## T43016 / T43017

VAG 1.8 Petrol

Fig. 1

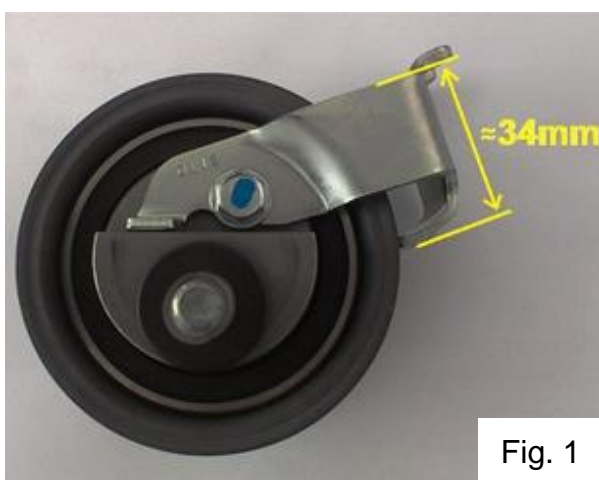
Tensioners T43016 (Fig. 2) and T43017 (Fig. 1) are used in combination with Timing Belt 5491XS.

Although both tensioners look identical at first sight, they are not interchangeable.

The difference is to be found in the orientation of the attacking arm, which differs by 3°.

The T43016 and T43017 are not interchangeable. Failure to use the appropriate kit and tensioner for this application will lead to incorrect tension. Premature belt failure and severe engine damage are inevitable consequences.
